NAVY EXPERIMENTAL DIVING UNIT

NAVY EXPERIMENTAL DIVING UNIT REPORT

MK 12 SSDS HELMET ADJUSTABLE EXHAUST VALVE ASSEMBLY EVALUATION

FIGURE 1. MK 12 SSS HELMET ADJUSTABLE EXHAUST VALVE ASSEMBLY RETROFIT AND DESIGN CHANGE PARTS LOCATION

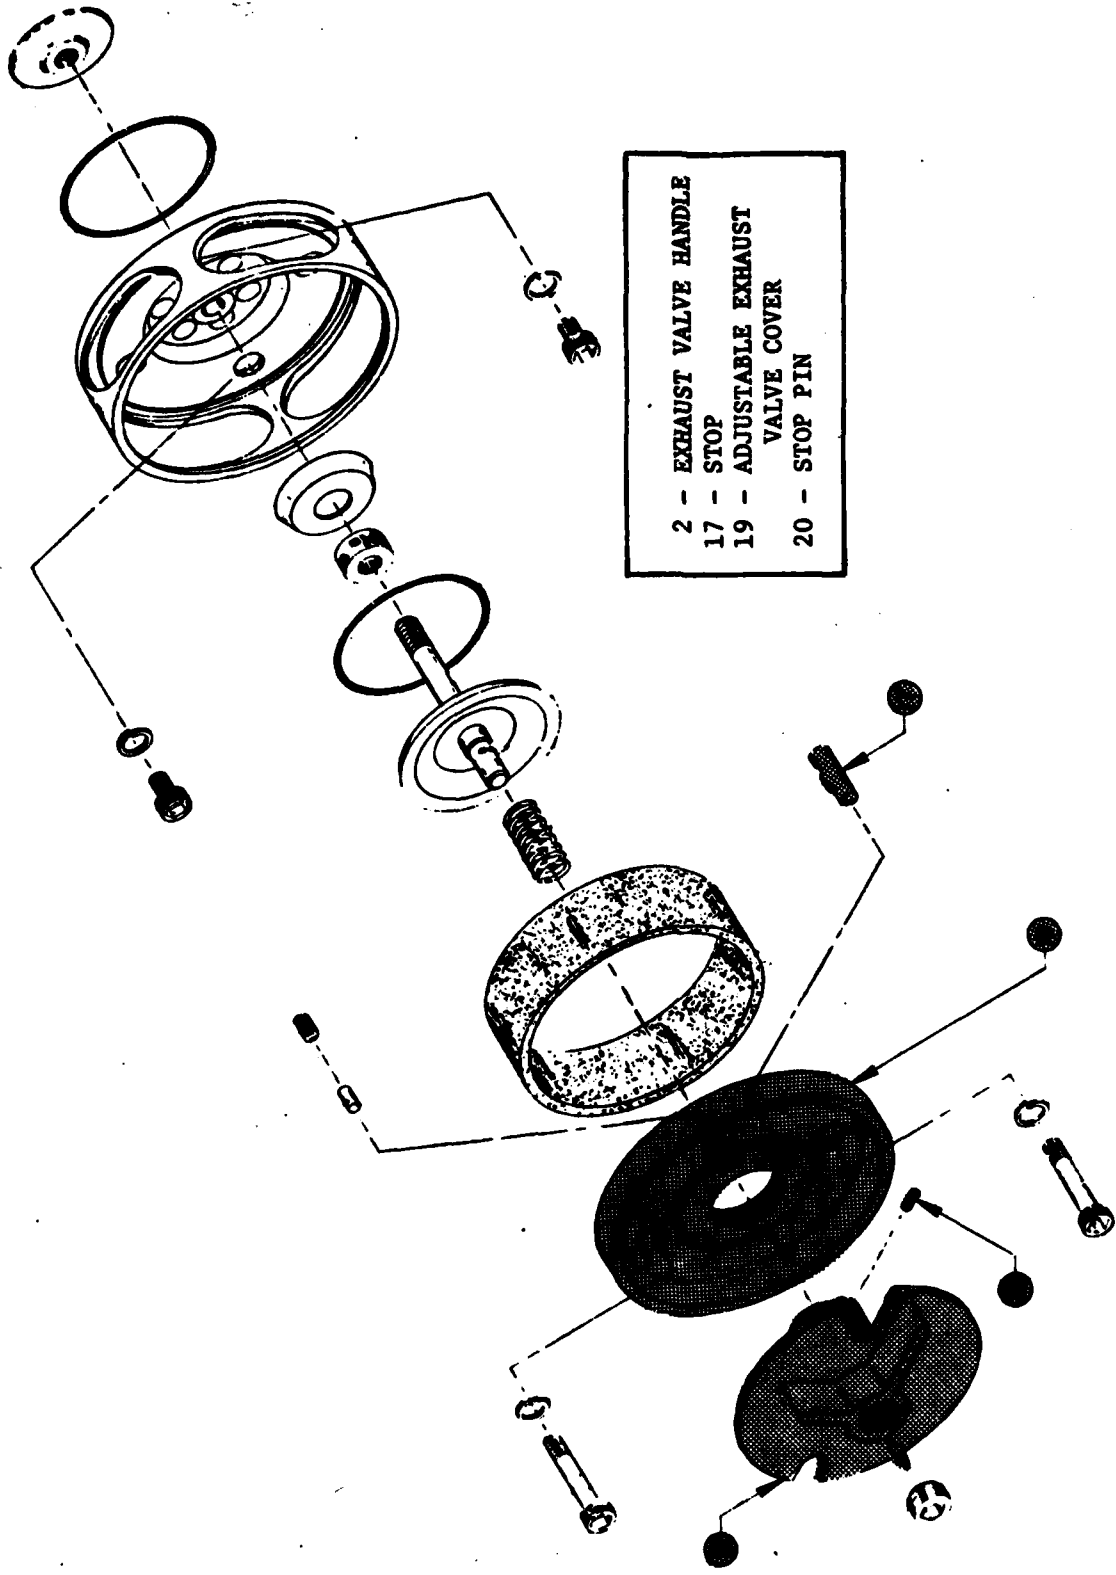
A summary of the findings outlined in the memorandum indicated that many of the existing stop pins had been plastically deformed during valve handle assembly. This condition is the result of inserting the tempered stop pin into a .004" to .006" undersized hole in the valve handle barrel. (See Figures 1 and 2).

FIGURE 2. PRIMARY FAILURE SITES ON MK 12 SSDS HELMET ADJUSTABLE EXHAUST VALVE ASSEMBLY

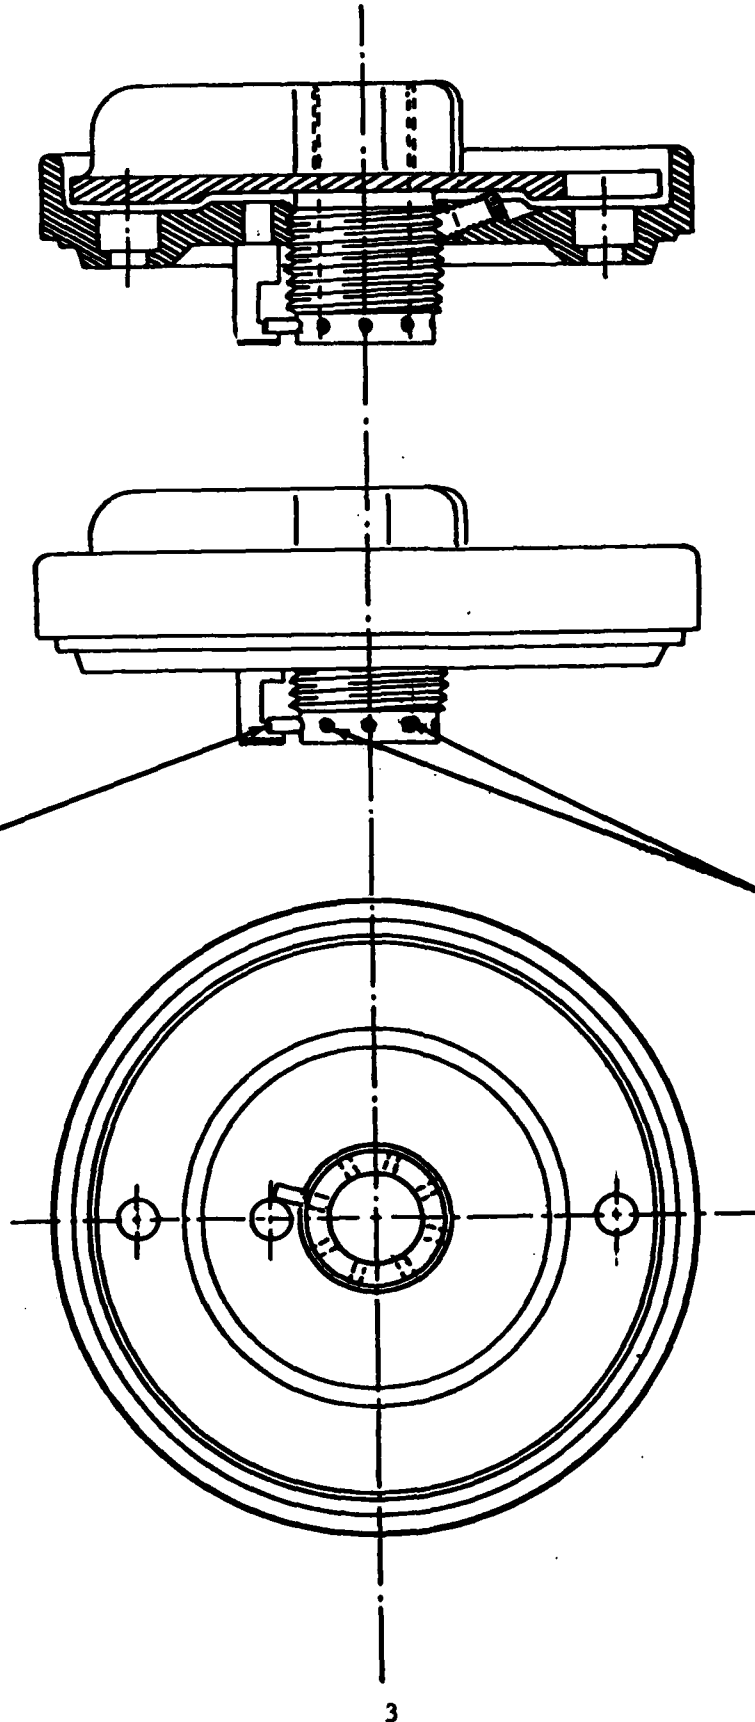
UNDERSIZED HOLES
.086 IN. DIAMETER
(SPECIFIED .090 IN./-.092 IN. ON DRAWING 592-475855)

d. The valves that failed were manufactured by Morse Diving Company. Inspection of these parts shows that the diameter of the pin holes was $.086''$ as opposed to the specified $.090''/.092''$ on the drawing. This undersized hole puts an excessive stress concentration on a pin of this temper. It has been noted that several of the valves, as received from the manufacturer, had these pins split at assembly. It is apparent that if the pin is split at assembly, the ability of the pin to remain in its hole as well as resist bending or breaking is considerably reduced.

FIGURE 3. PROPOSED RETROFIT - MK 12 SSS HELMET ADJUSTABLE EXHAUST VALVE ASSEMBLY

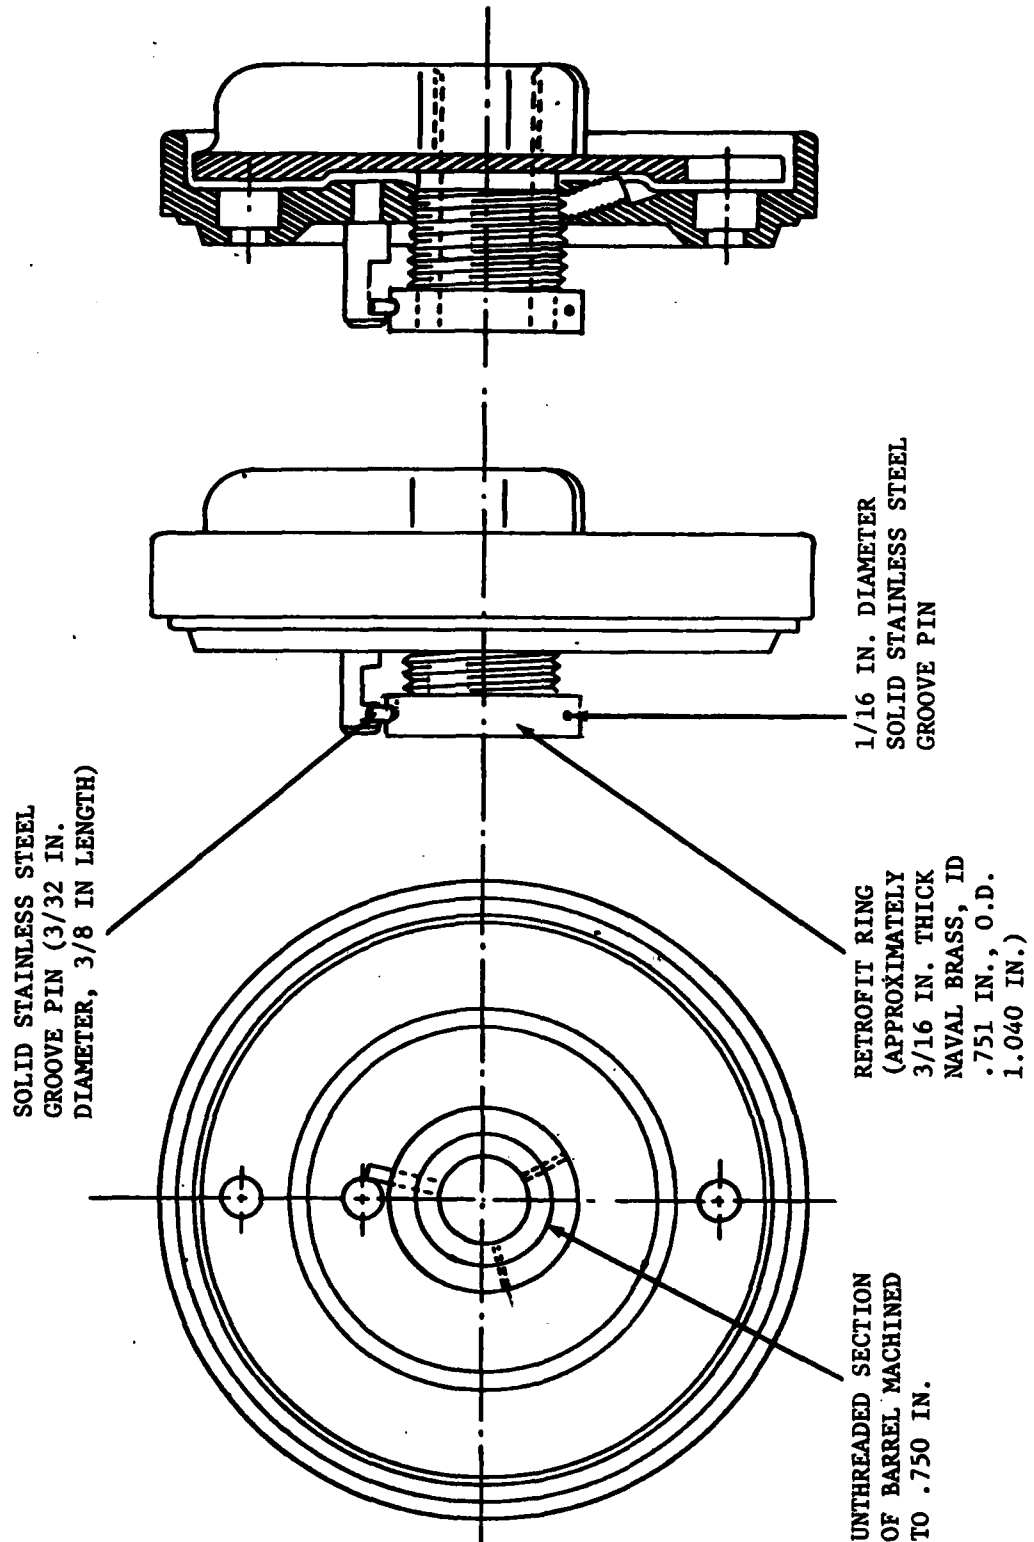
Based on the preceding test results and other available data, the following Retrofit is recommended for existing MK 12 SSDS helmet adjustable exhaust valve assemblies: (See Figure 3).

1. Machine unthreaded section of the valve handle barrel to .750 in.
2. Produce a ring of naval brass approximately 3/16 in. thick, ID .751 in. and OD 1.040 in., radially drilled with one 3/32 in. center hole.
3. Open the selected hole in the valve handle barrel to 3/32 in.
4. Position ring on barrel and secure with a solid stainless steel groove pin, 3/8 in. long and 3/32 in. diameter, pressed in place.
5. Radially drill two additional center holes through the ring and barrel 1/16 in. in diameter, and press solid stainless steel groove pins, 1/4 in. long and 1/16 in. diameter in place. Position of new holes in ring and barrel will be determined by available stock between existing holes.

FIGURE 4. PROPOSED DESIGN CHANGE - MK 12 SSDS HELMET ADJUSTABLE EXHAUST VALVE ASSEMBLY

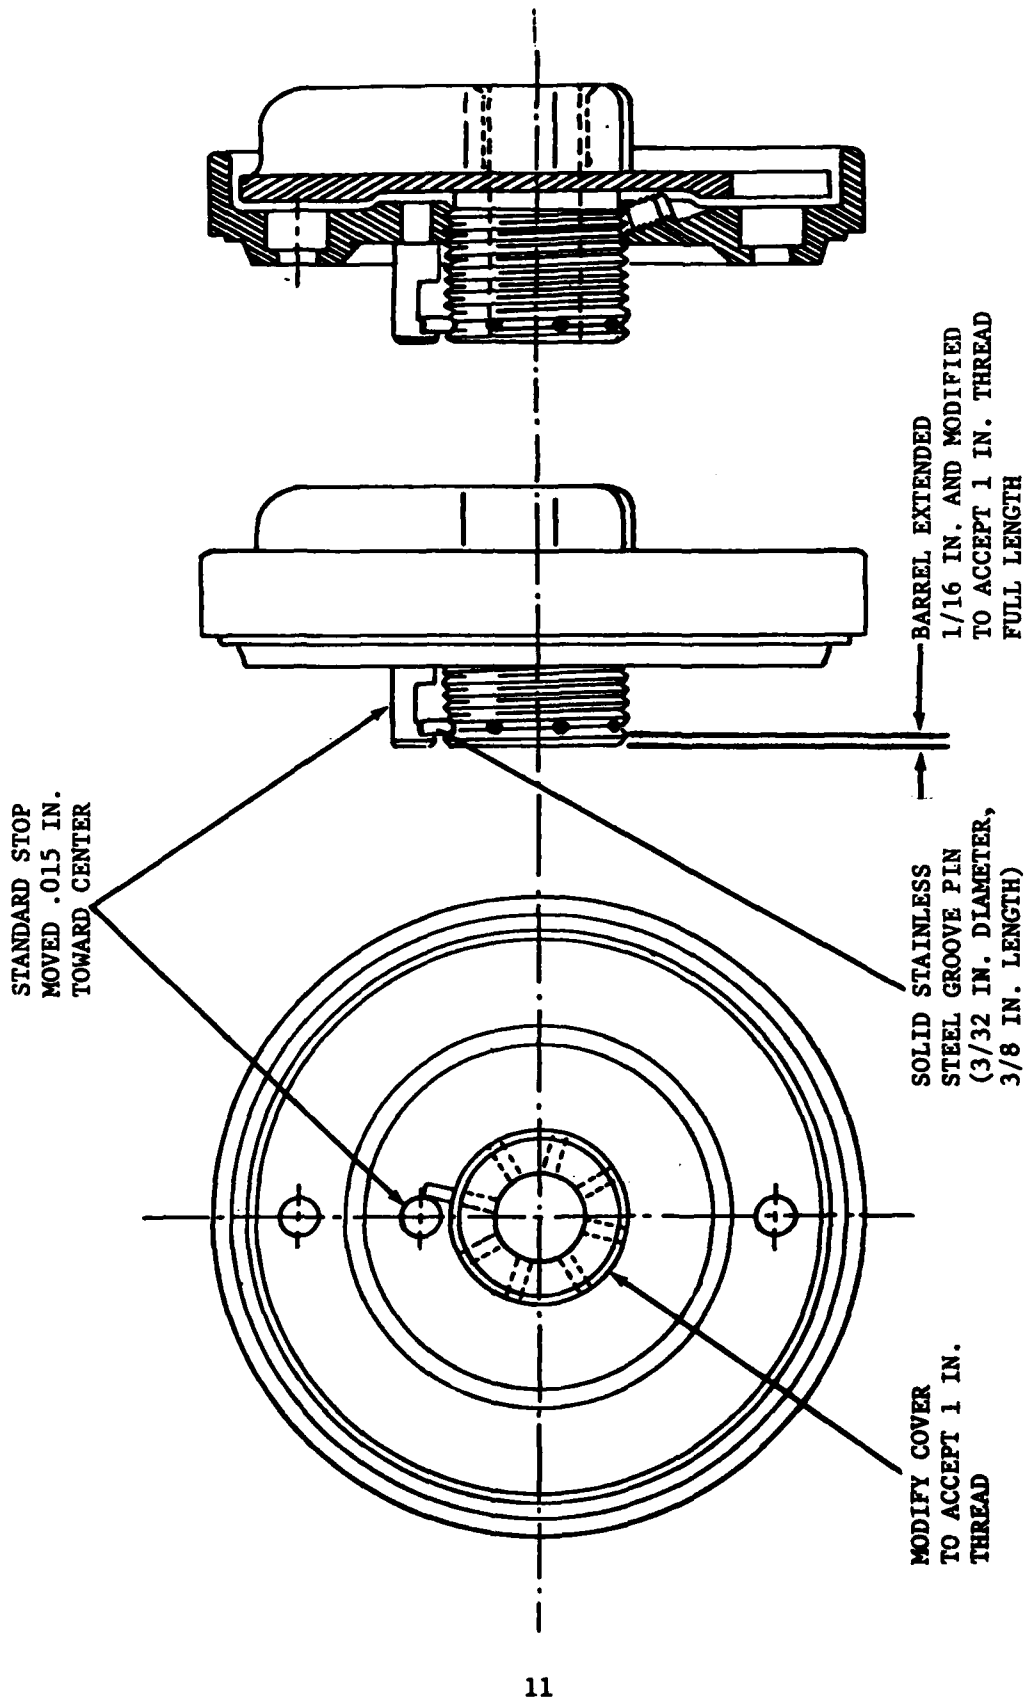
The following design changes are recommended for new procurement: (See Figure 4).

1. Modify the valve handle barrel to be extended 1/16 in. in length and accept a full length 1-12 UNC-2A thread. (Length extension allows more material between the holes and the edge of the part).
2. Install the same 3/8 in. grooved pin described in the retrofit.
3. Move the stop .015 in. closer to the center of the exhaust valve handle.
4. Rethread adjustable exhaust valve cover to accept the 1-12 UNC-2B thread and relocate the stop hole .015 in. closer to the center of the cover.

ENCLOSURE 1

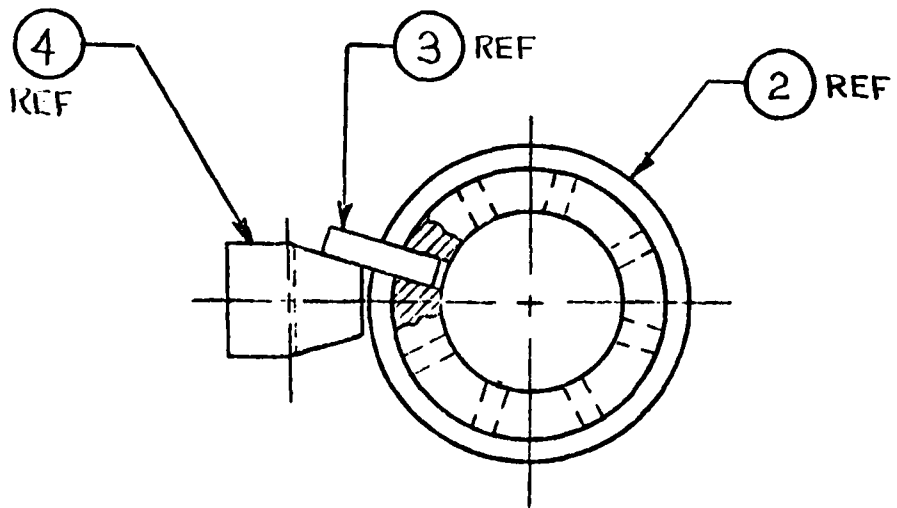
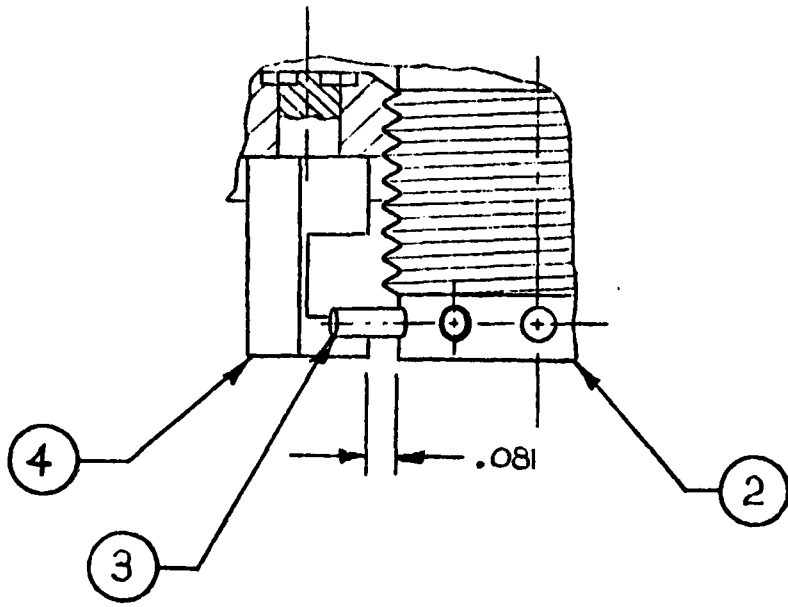
a. A retrofit to existing valves in the nature of a redesign of the pin stop (see Encl. 1). The present pin and stop configuration sees a moment arm on the pin of .242" and requires a force on the valve handle of approximately 60" lbs. to fail. The proposed retrofit would reduce the moment arm to .081" and require a force of approximately 180" lbs. to fail. This retrofit would require a minimum effort, as it only requires that the existing pin stop be pressed out of the exhaust valve cover, the existing hole be reamed slightly larger; and the new pin stop pressed in. We feel that this change, with proper manufacturing and user technique, should be an acceptable solution to the problem in the existing valves.

ENCLOSURE 2

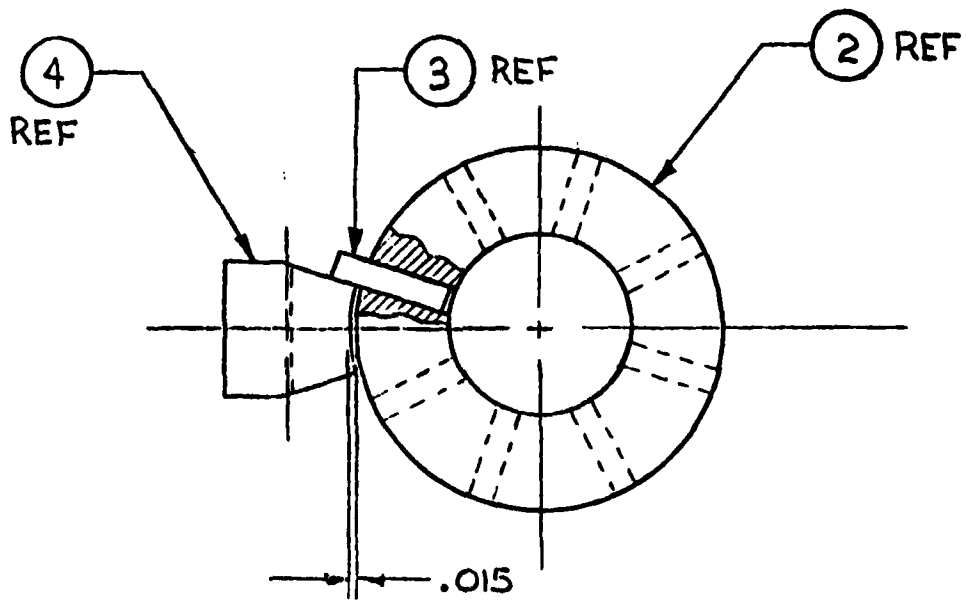
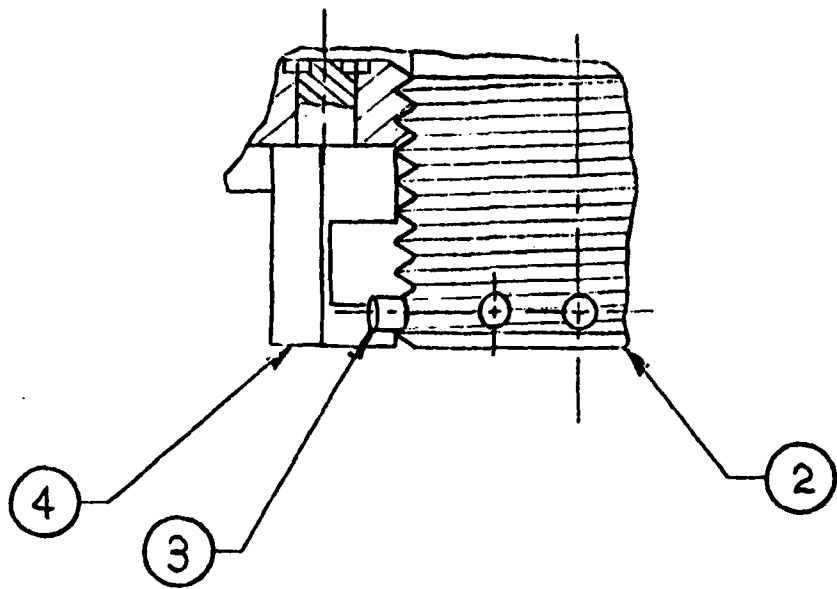
b. We would recommend a revision for future buys which would also be simple to implement but would offer a considerable increase in strength over the retrofit. (See Encl. 2) This change would increase the .875" thread diameter to 1.000" diameter on the valve cover and handle. This would increase the available material thickness from .125" to approximately .250" in the area of the pin engagement. With this added material, a solid pin may be used to replace the spring pin now used. This design change also allows a reduction of pin moment arm to .015". This configuration would require a force in excess of 600" lbs. to cause failure.

The above change would require no change to the existing cover pattern, but a minor change to the pattern for the handle.
